# Amendment Report

EnergyConnect (NSW – Eastern Section)

May 2022

Figure 3-7

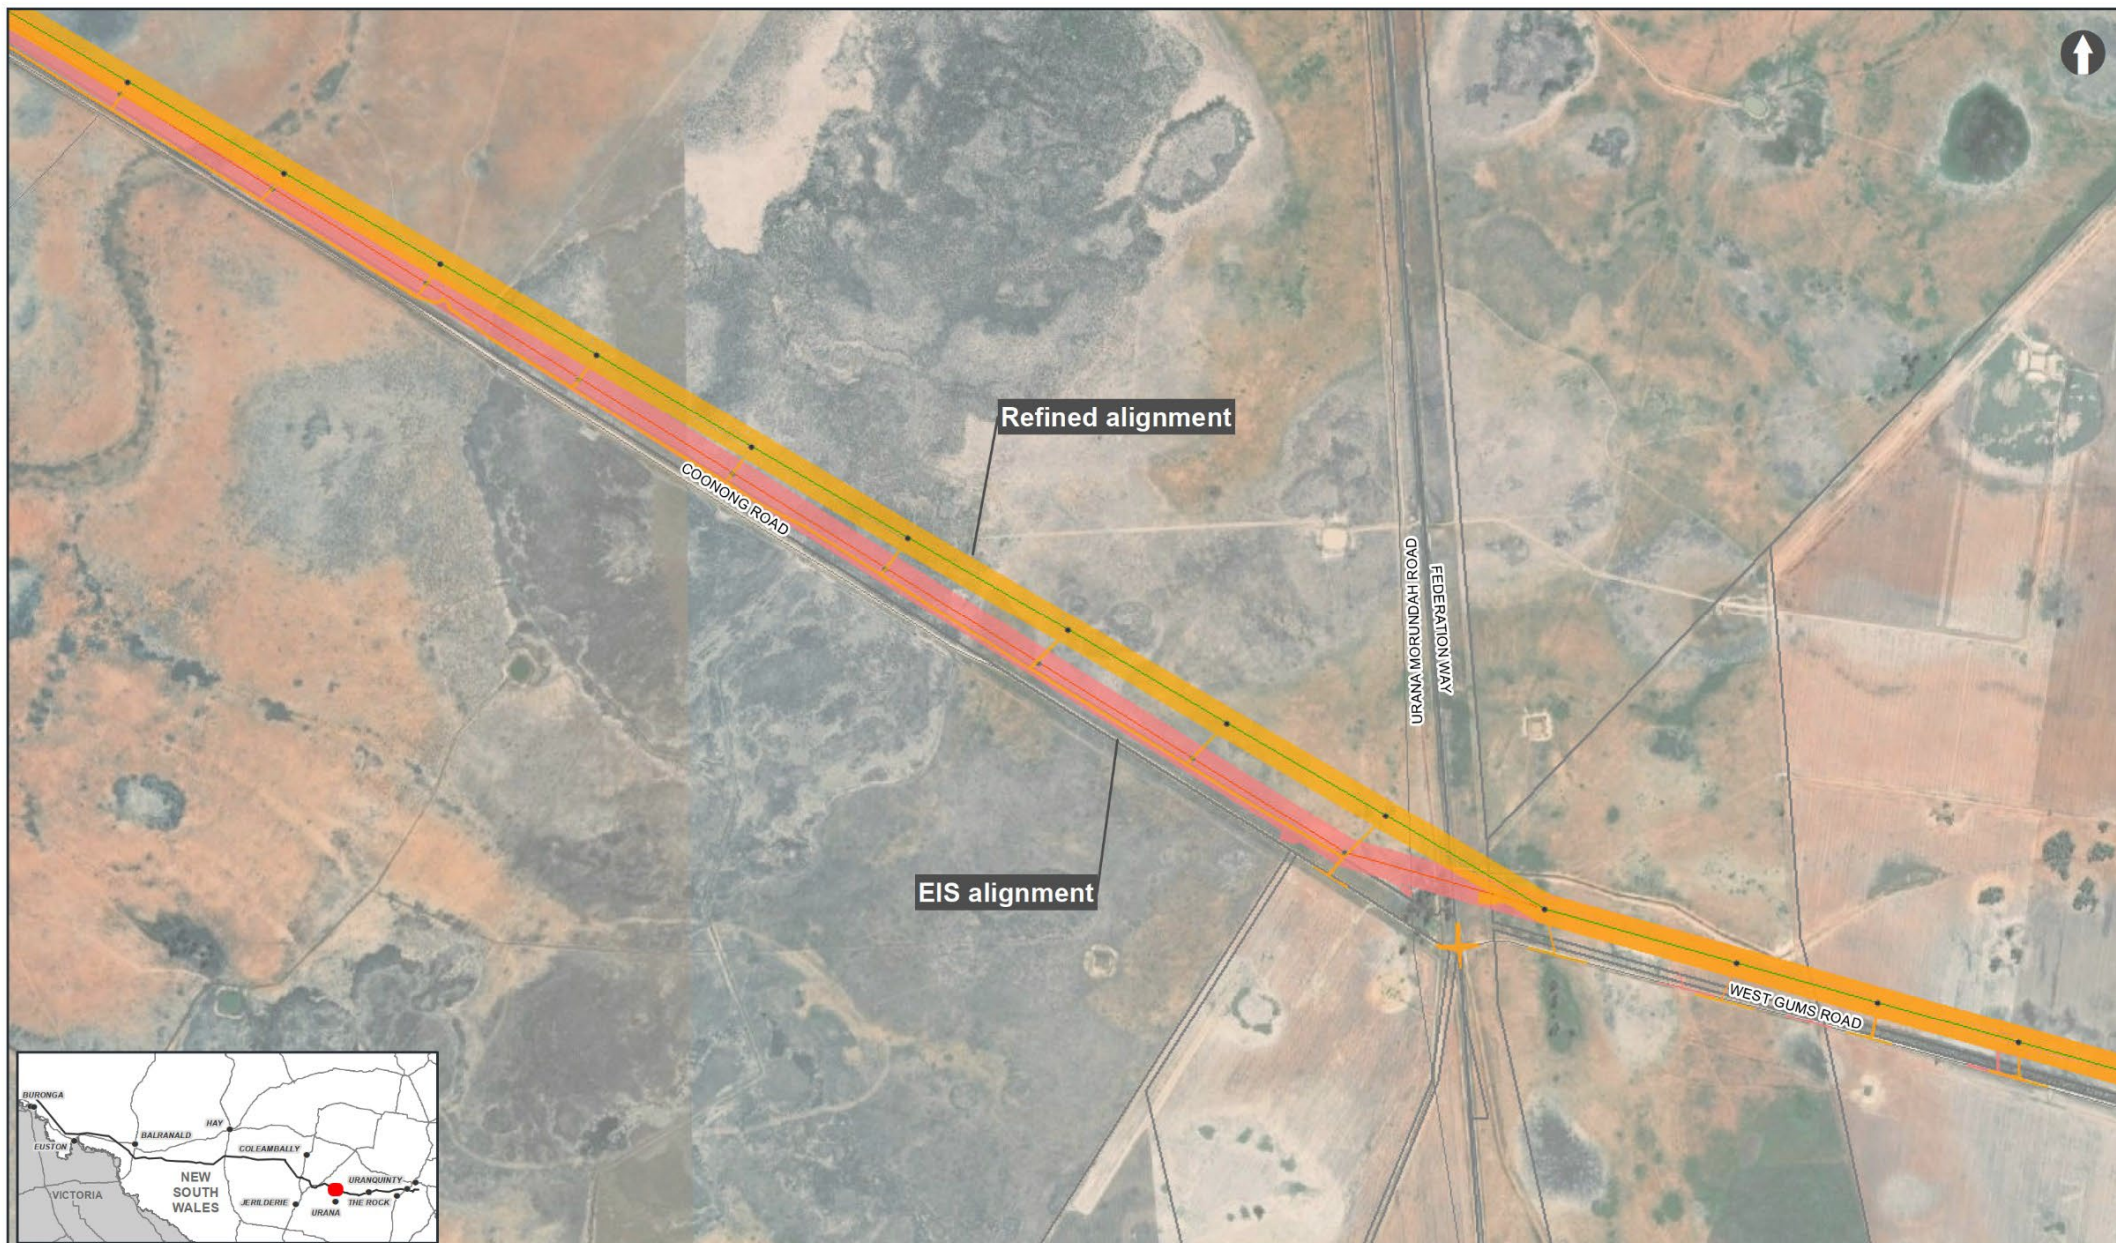
The refined alignment was primarily driven by the request of the land holder to avoid the existing stand of River Red Gum trees on the eastern part of the property adjacent to Federation Way. This refinement would provide improved biodiversity outcomes.

Figure 3-7 shows a comparison between the EIS alignment and the refined alignment at Urana, west of Federation Way.

**Figure 3-10**

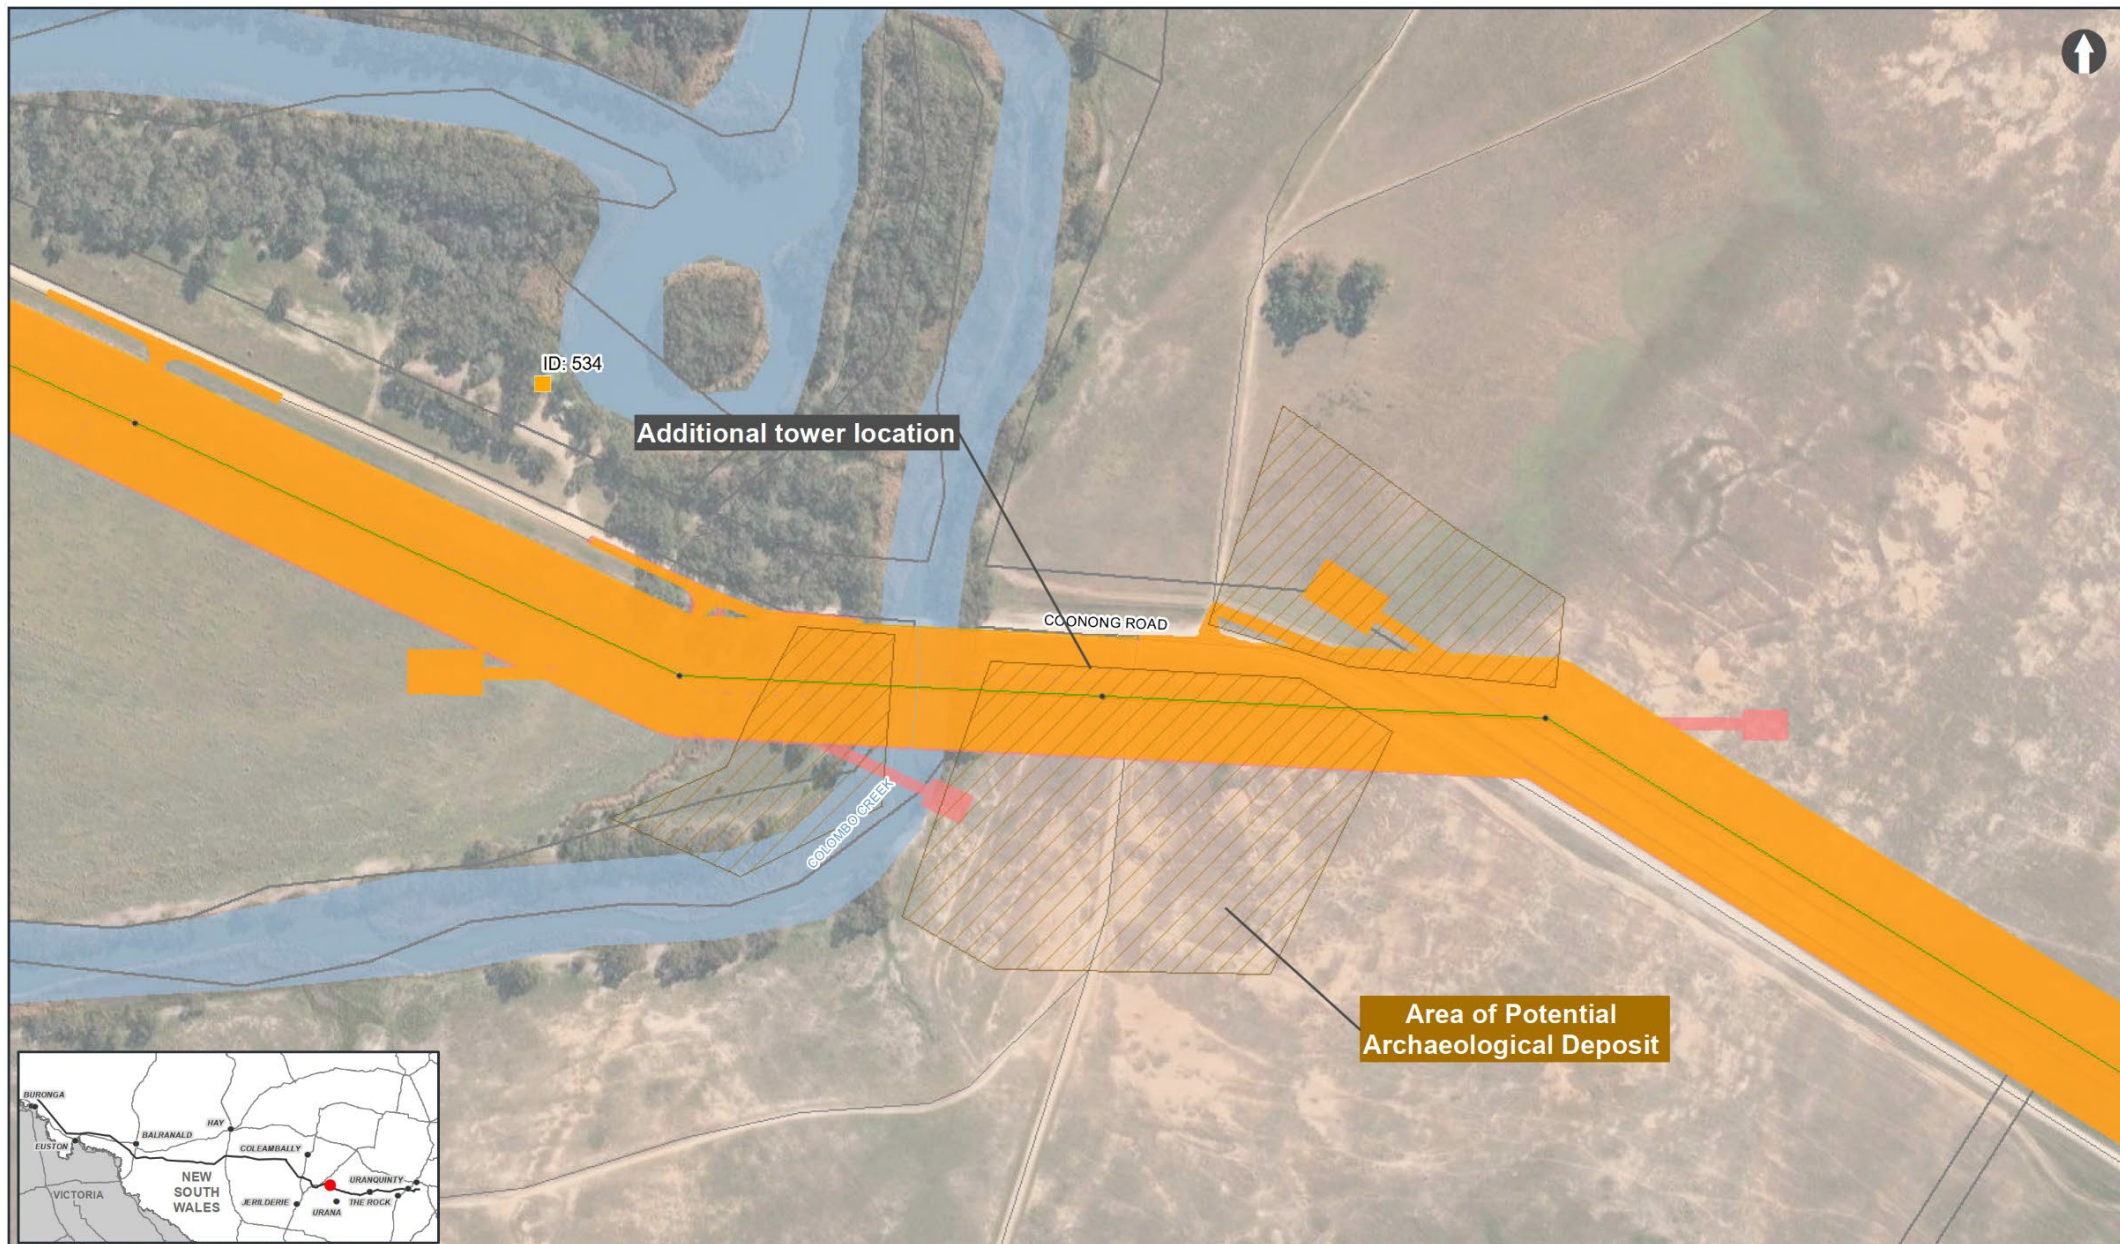
Figure 3-10 shows the location of the proposed additional transmission line tower in relation to the identified PAD site, east of Colombo Creek.

**Figure 3-11**  
Figure showing the revised site arrangement for the construction compound and accommodation camp site at Cobb Highway

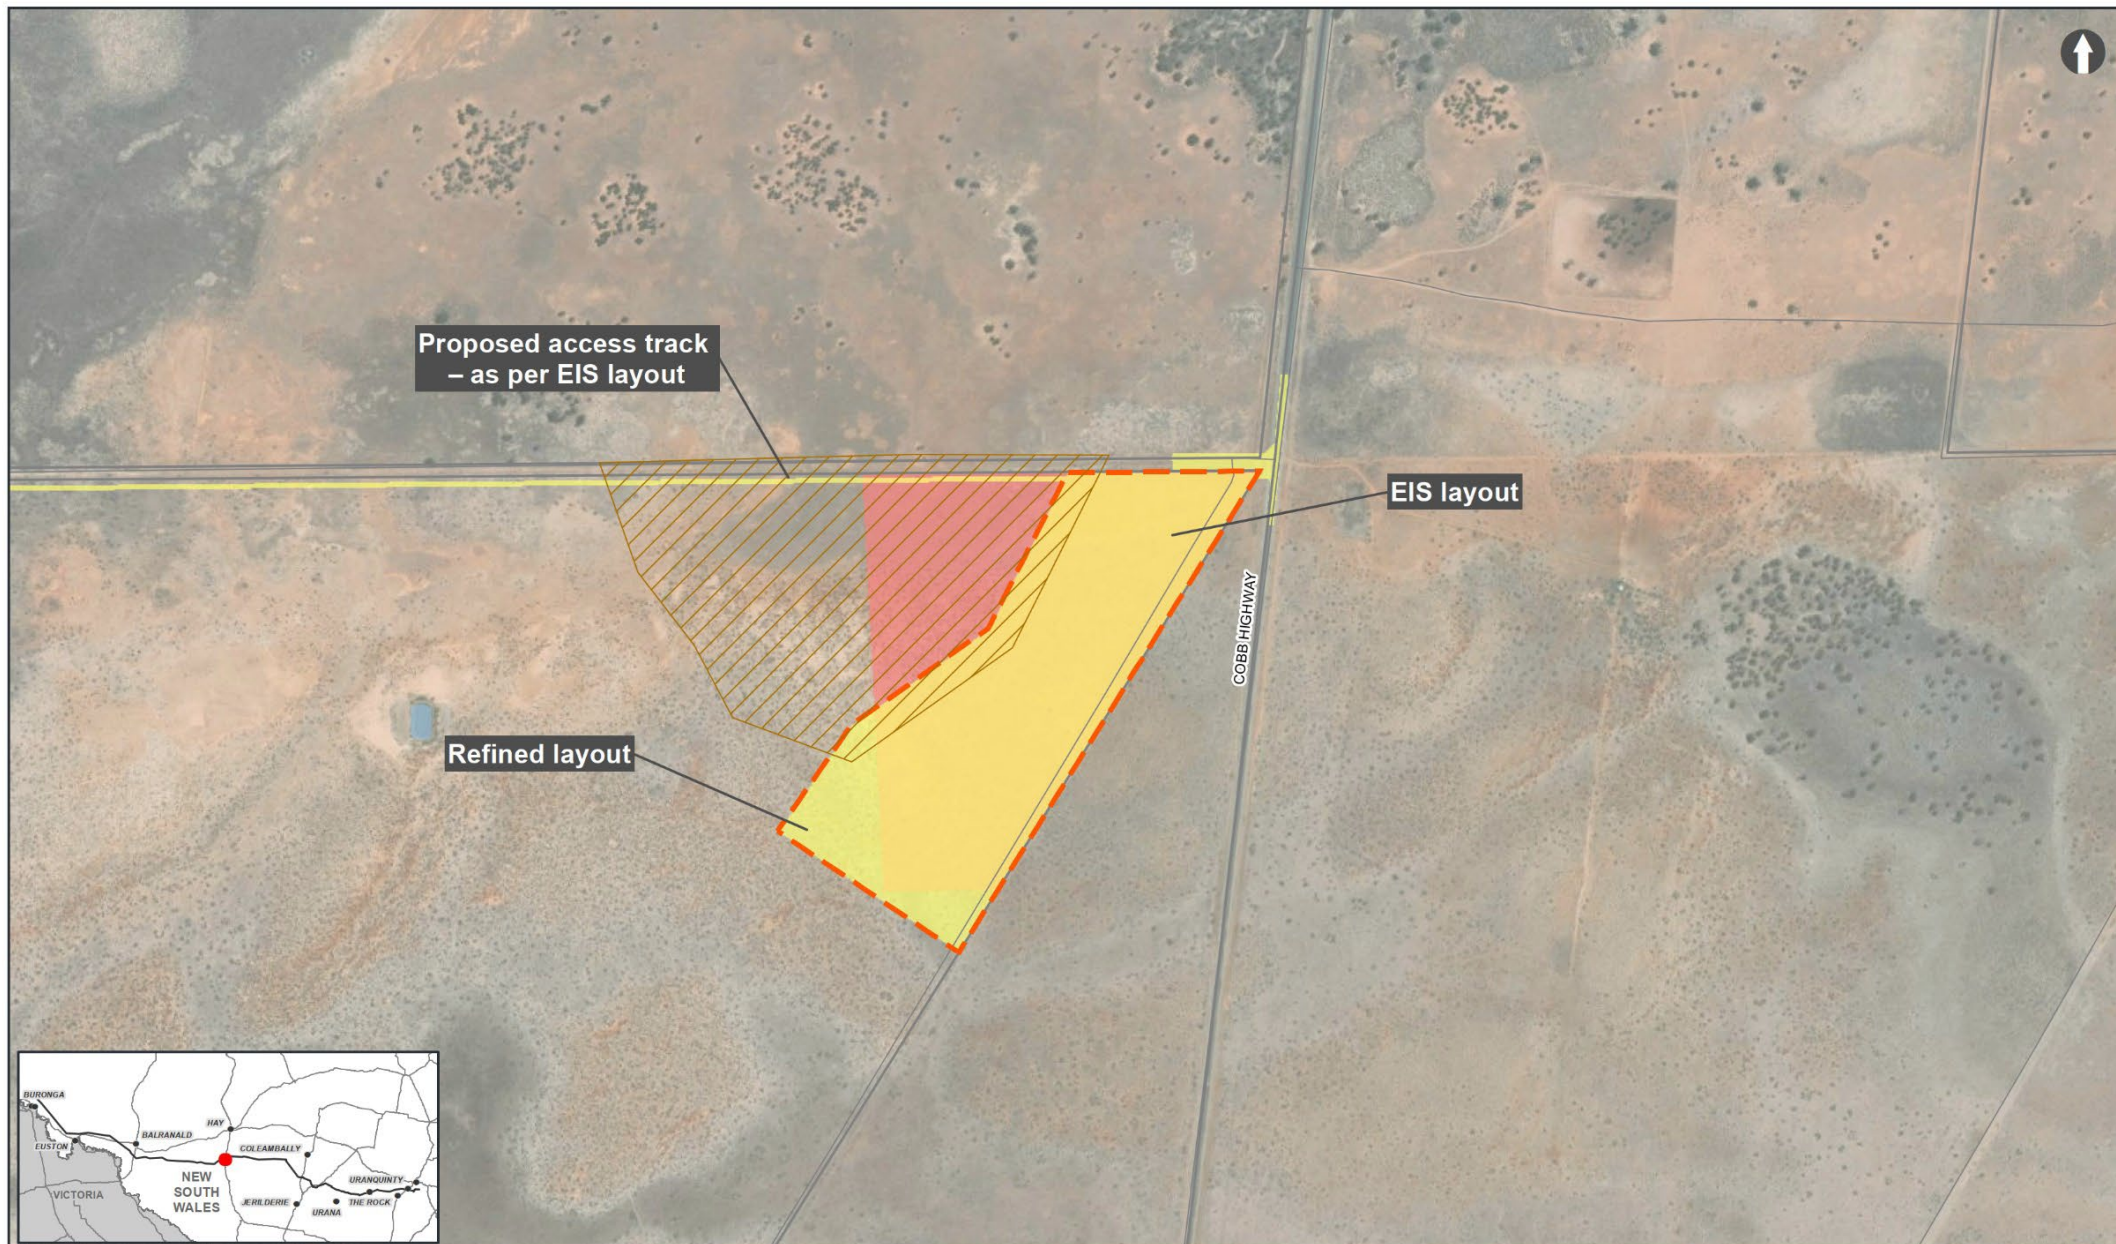
In order to minimise potential impacts to this PAD, a revised site arrangement for the construction compound and accommodation camp has been developed. The revised arrangement is shown in Figure 3-11.
